# Access Compliance Report

## Public Rights-of-Way (Curb Ramps)

Intersection ID: 10041795	Main Street: WILLIAMS_POND_LN	Cross Street: N/A	Location:	N
ADA ID: 9A4AC602DDEF	Ramp Type: BlendTrans1	Initial Pass/Fail: Fail	Overall Compliance: No	Severity Score: 1.25
Codes/Mitigation Info/Possible Solution		Field Measurements/Component Compliance

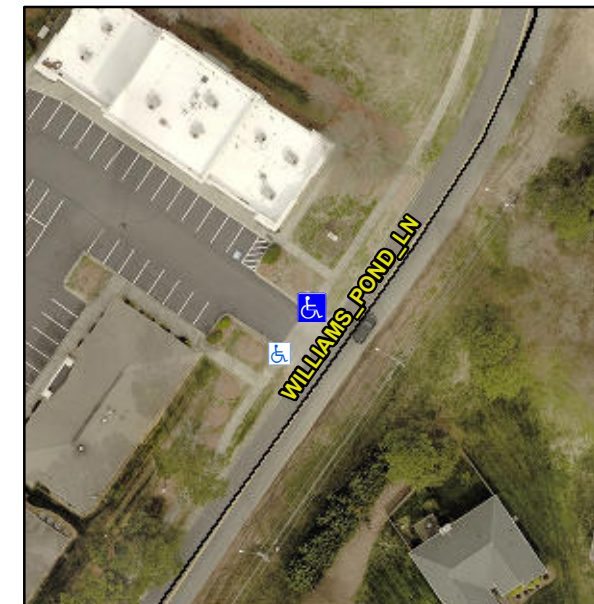
**Not Found, R304.5.3**

**Remove & Replace Curb Ramp With Two New Directional Ramps or Equivalent.**
